Planning and Strategy Committee of the Whole

12 August 2020

Item 7.4	Modification Application 82/96.A - Modification of Eight Lot Torrens Title Subdivision - 536 Duckfield Road, Boro	
	<i>Attachment 1</i>	<i>DA 82/96.A - Sec 96(2) Assessment - 536 Duckfield Road, Boro.....2</i>
	<i>Attachment 2</i>	<i>DA 82/96.A - Modified Lot Configuration Plan - 536 Duckfield Road, Boro 11</i>
	<i>Attachment 3</i>	<i>DA 82/96.A - Submission - 536 Duckfield Road, Boro..... 13</i>
	<i>Attachment 4</i>	<i>DA 82/96.A - 82/96 Notice of Determination and Approved Plan - 536 Duckfield Road, Boro..... 15</i>
	<i>Attachment 5</i>	<i>DA 82/96.A - Previous Council Report - 536 Duckfield Road, Boro.....21</i>

Item 7.5	Modification Application 83/96.A - Modification of Ten Lot Torrens Title Subdivision - 536 Duckfield Road, Boro	
	<i>Attachment 1</i>	<i>DA 83/96.A - 96(2) Assessment - 536 Duckfield Road..... 36</i>
	<i>Attachment 2</i>	<i>DA 83/96.A - Modified Lot Configuration Plan - 536 Duckfield Road..... 45</i>
	<i>Attachment 3</i>	<i>DA 83/96.A - Submission - 536 Duckfield Road..... 47</i>
	<i>Attachment 4</i>	<i>DA 83/96.A - Notice of Determination and Approved Plans - 536 Duckfield Road..... 49</i>

Figure 6: TDCP No.4 Road Standards

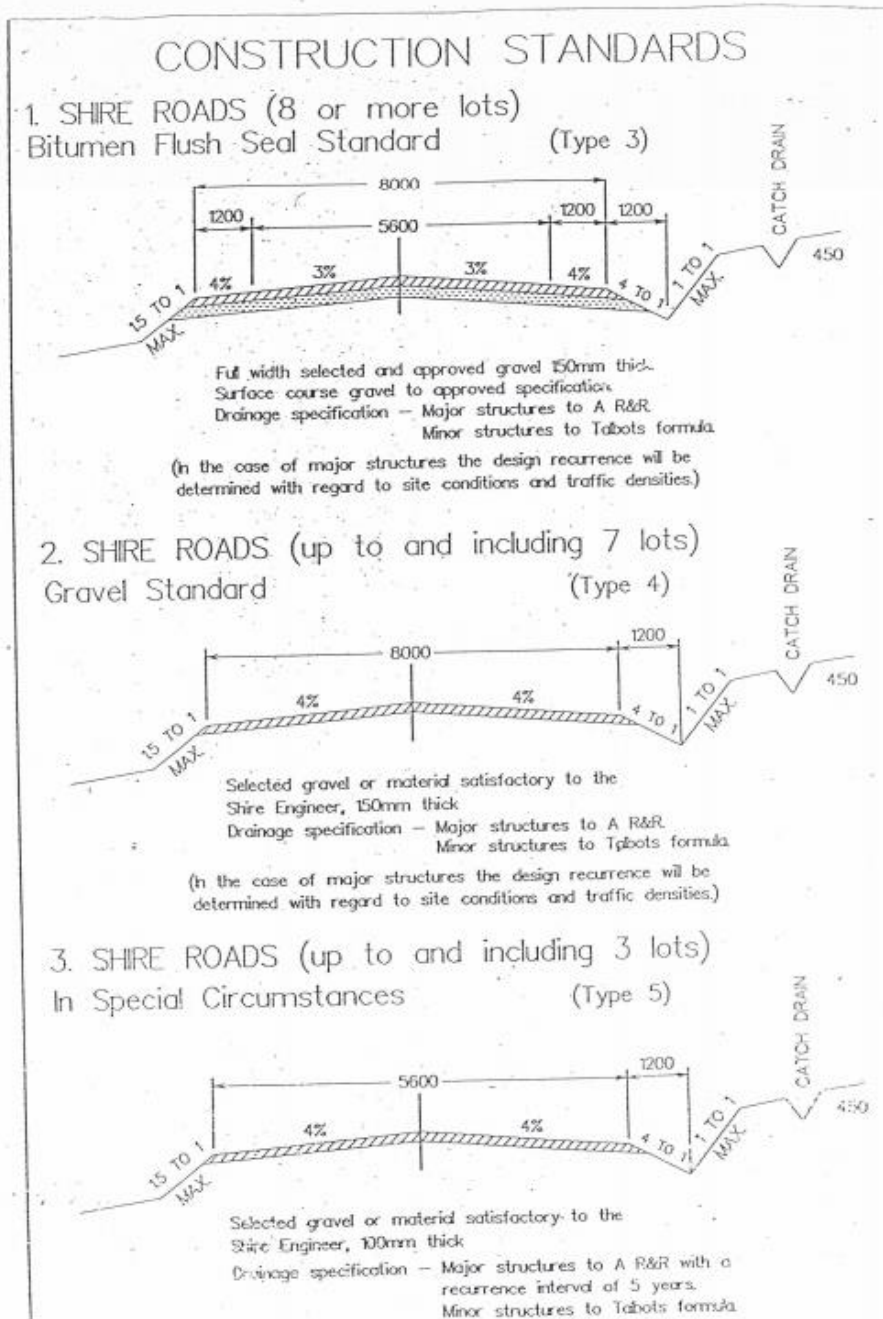
While since repealed the *Tallaganda Development Control Plan (TDCP) No.4 – Rural 1(A)* is the applicable development control plan for the purposes of the subject modification application. While the proposed allotments configuration as modified is generally consistent with the relevant provisions of the TDCP No.4, the proposed road standard being a gravel formation would result in a variation to the minimum road construction standard for the purposes of subdivision as established under Section 2.19 of the TDCP No.4. Figure 6 below provides a diagrammatic summary of the requirements of Section 2.19 of the TDCP No.4. Importantly it should be noted for subdivisions involving 8 or more lots, such as the subject development, requires the construction of an 8m wide road formation including a minimum 5.6m wide sealed carriageway.

Despite condition 5 of DA 80/92 requiring road upgrade works to Council's standard for 8 or more lots, as DA 80/92 resulted in only seven lots it should not have triggered the requirement for the sealing of Duckfield Road. However, both DA 82/96 and DA 83/96

resulting eight and ten lots respectively would require sealing of the length of Duckfield road from its intersection with MR79 (Goulburn Road) to each of the proposed allotments.

In the interest of comparison, if current construction standards were applied to the proposal a minimum 9.2m wide road formation including a 7.2m wide sealed carriageway would be required under Council's Development Design Specification D1 – Geometric Road Design (Urban and Rural).

ATTACHMENT 2 DA 82/96.A - MODIFIED LOT CONFIGURATION PLAN - 536
DUCKFIELD ROAD, BORO

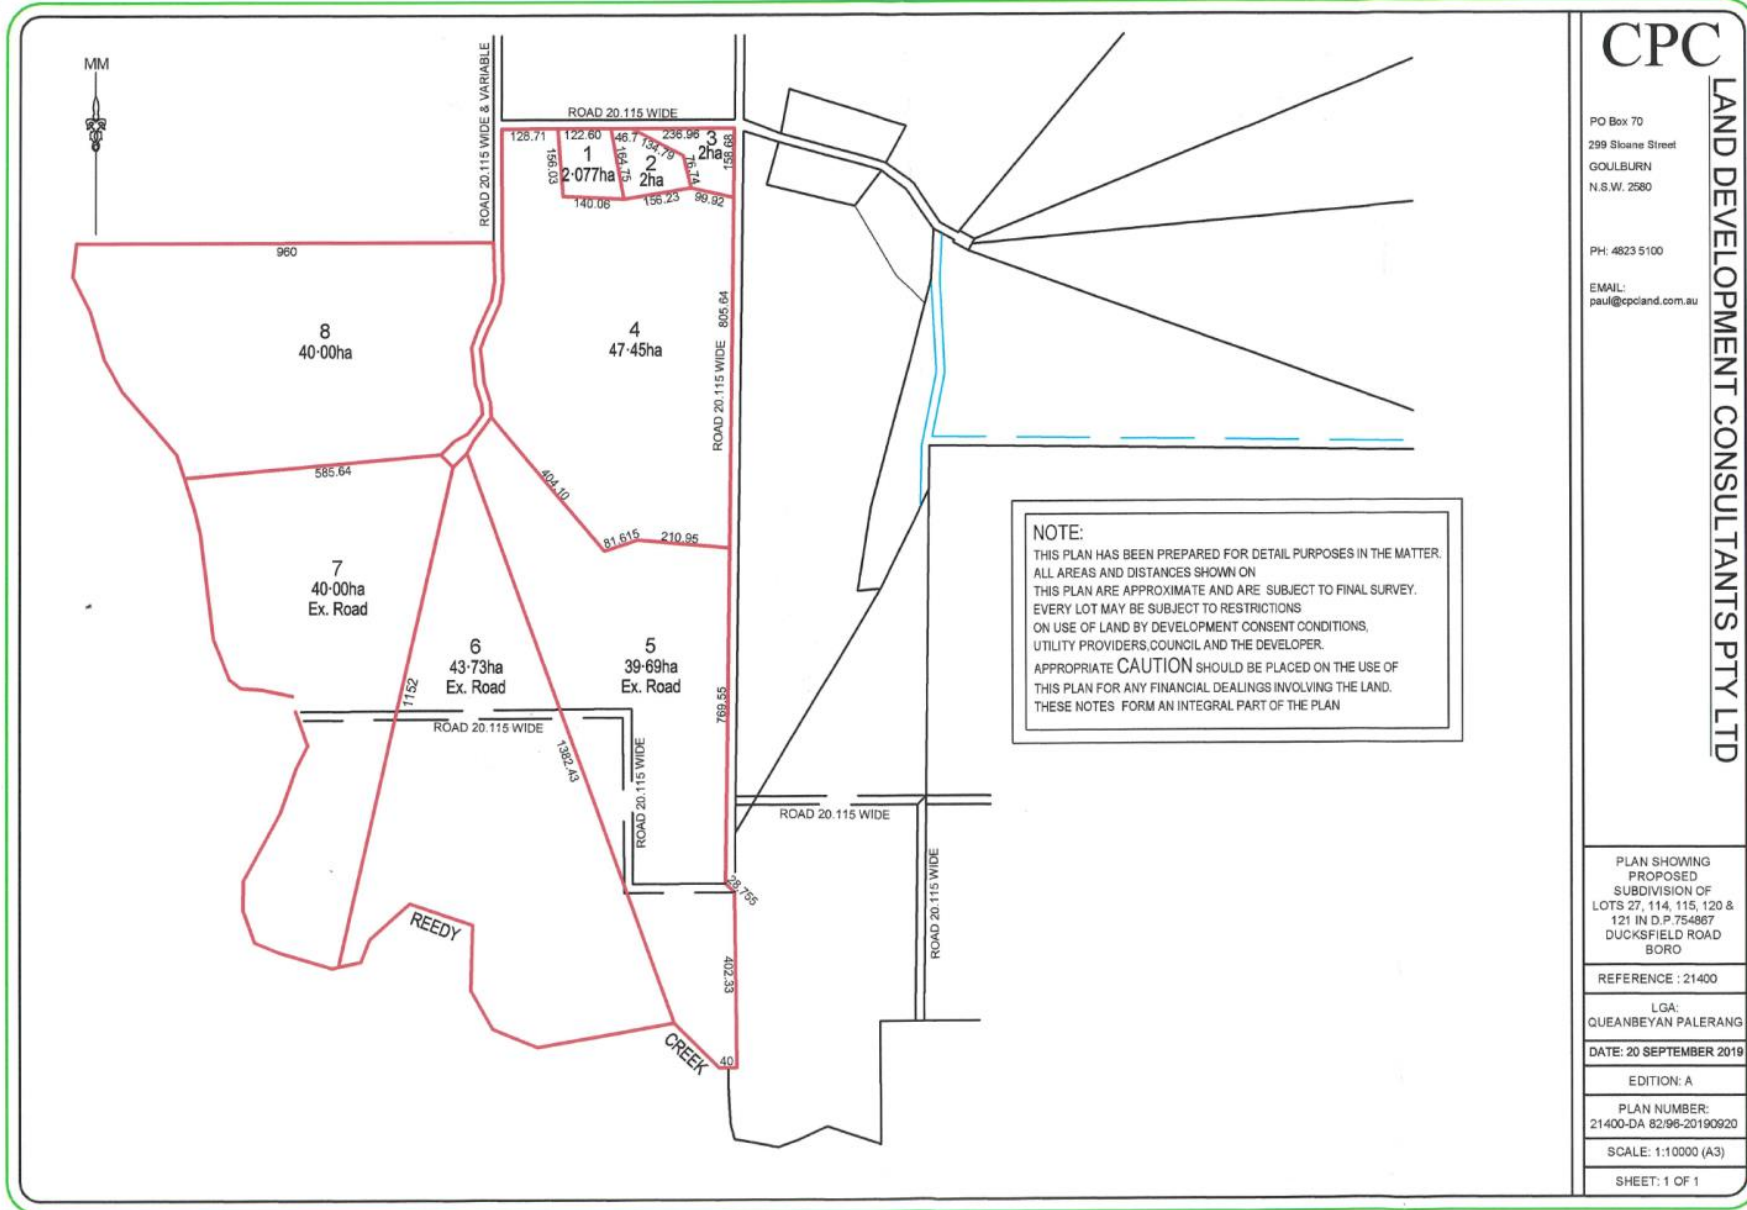
In general the proposed modification improves the capacity for the allotments to accommodate for future residential development by providing lot boundaries that are more considerate of the topographical constraints of the land. However, given the age of both the parent consent and the subject modification which predate current legislative requirements in relation to bushfire and threatened species any future application for the purposes of a dwelling will need to consider compatibility of the dwelling site with the bushfire risk and flora and fauna present upon the site.

Figure 1: TDCP No.4 Road Standards

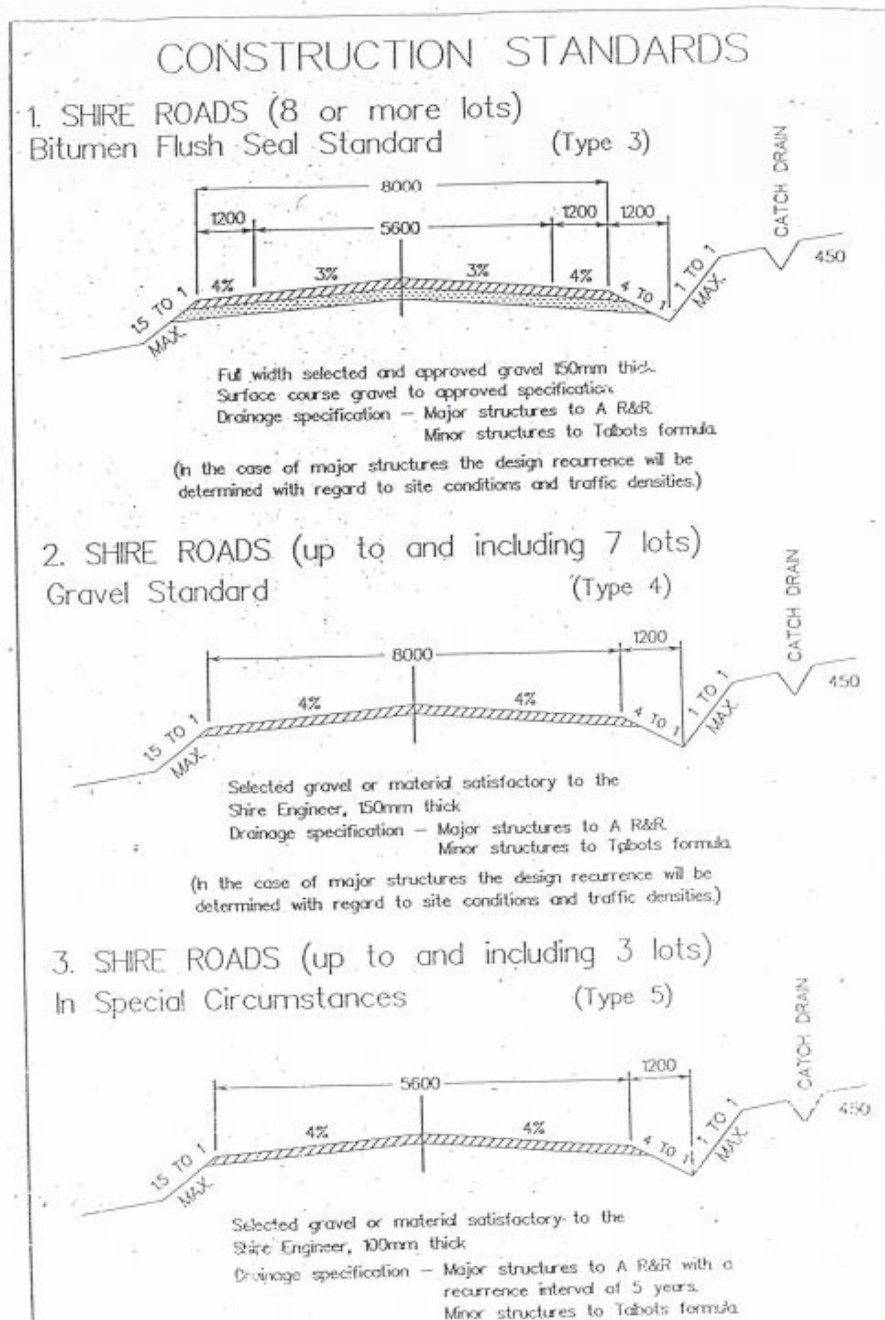
While since repealed the *Tallaganda Development Control Plan (TDCP) No.4 – Rural 1(A)* is the applicable development control plan for the purposes of the subject modification application. While the proposed allotments configuration as modified is generally consistent with the relevant provisions of the TDCP No.4, the proposed road standard being a gravel formation would result in a variation to the minimum road construction standard for the purposes of subdivision as established under Section 2.19 of the TDCP No.4. Figure 1 below provides a diagrammatic summary of the requirements of Section 2.19 of the TDCP No.4. Importantly it should be noted for subdivisions involving 8 or more lots, such as the subject development, requires the construction of an 8m wide road formation including a minimum 5.6m wide sealed carriageway.

Despite condition 5 of DA 80/92 requiring road upgrade works to Council's standard for 8 or more lots, as DA 80/92 resulted in only seven lots it should not have triggered the

requirement for the sealing of Duckfield Road. However, both DA 82/96 and DA 83/96 resulting eight and ten lots respectively would require sealing of the length of Duckfield road from its intersection with MR79 (Goulburn Road) to each of the proposed allotments.

In the interest of comparison, if current construction standards were applied to the proposal a minimum 9.2m wide road formation including a 7.2m wide sealed carriageway would be required under Council's Development Design Specification D1 – Geometric Road Design (Urban and Rural).

ATTACHMENT 2 DA 83/96.A - MODIFIED LOT CONFIGURATION PLAN - 536
DUCKFIELD ROAD

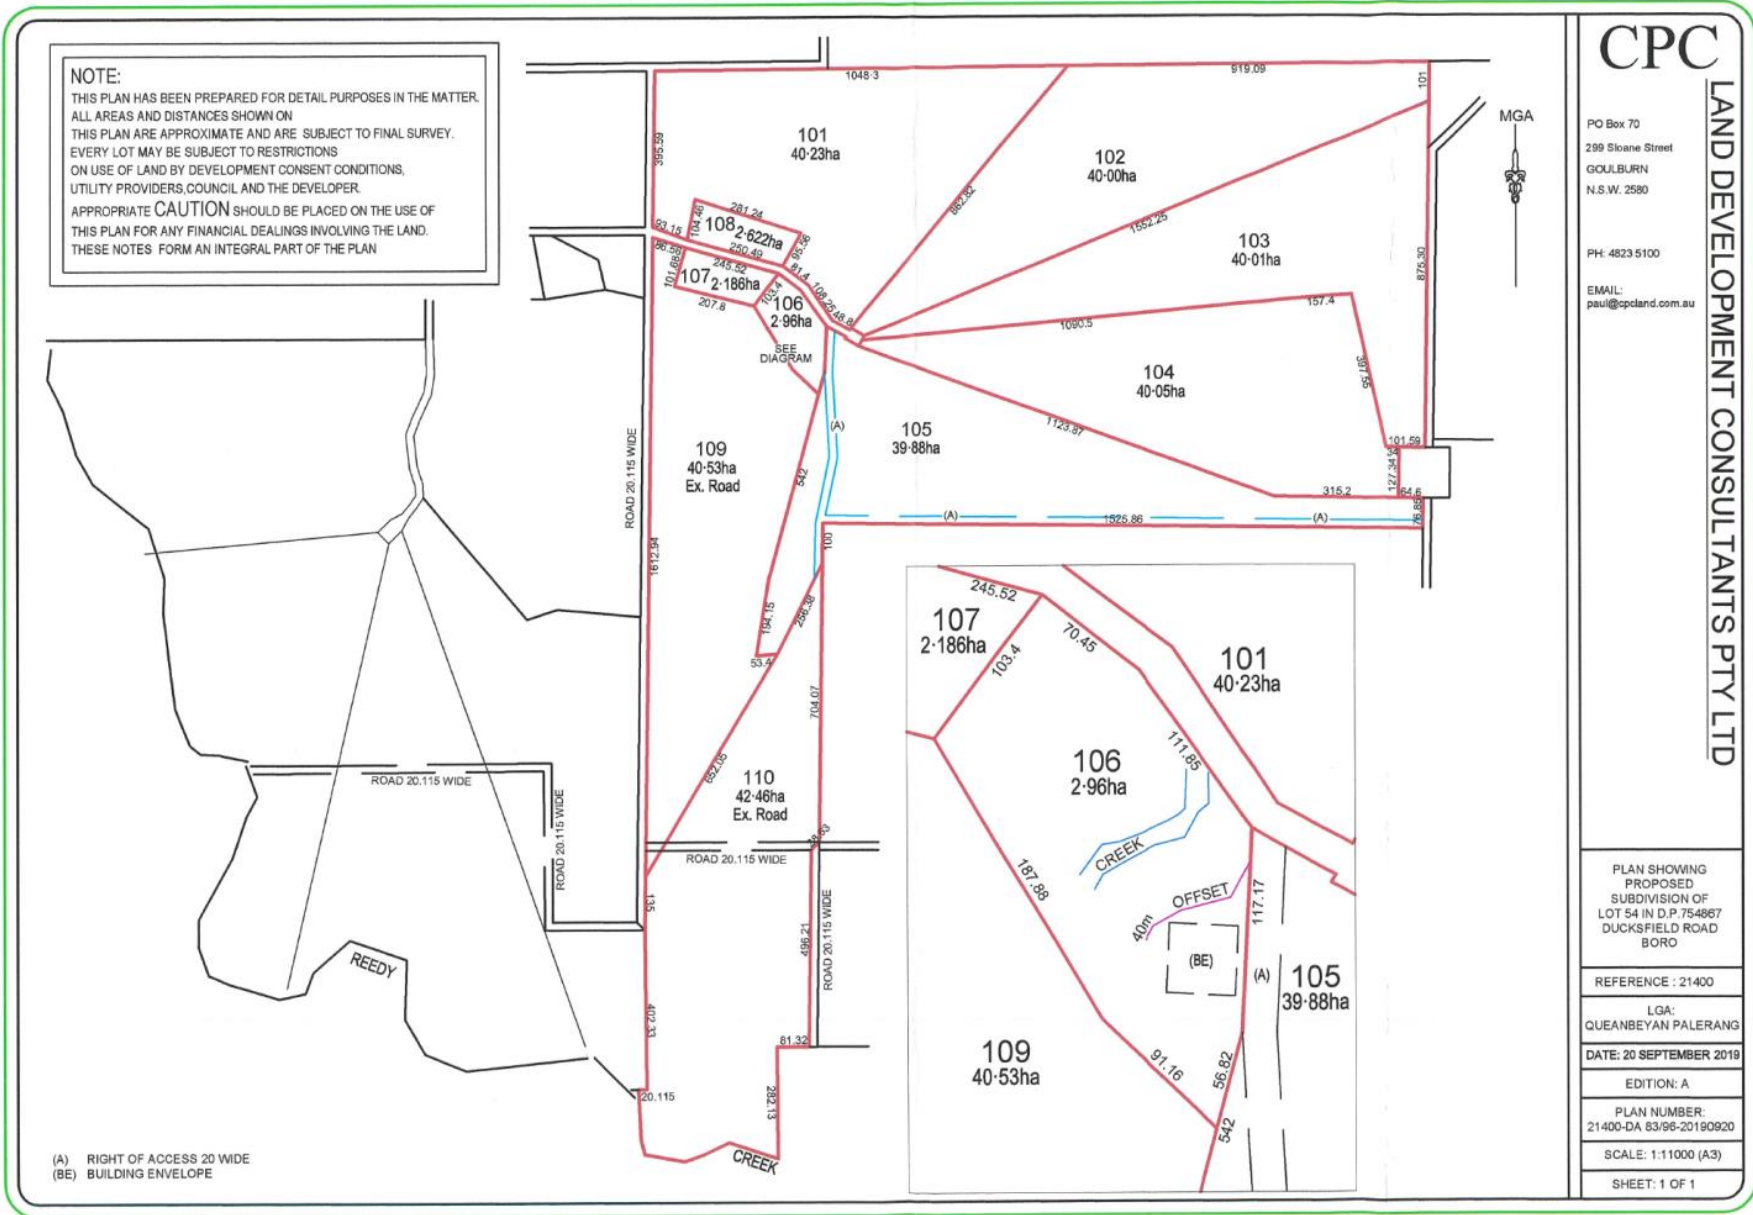
In general the proposed modification improves the capacity for the allotments to accommodate for future residential development by providing lot boundaries that are more considerate of the topographical constraints of the land. However, given the age of both the parent consent and the subject modification which predate current legislative requirements in relation to bushfire and threatened species any future application for the purposes of a dwelling will need to consider compatibility of the dwelling site with the bushfire risk and flora and fauna present upon the site.
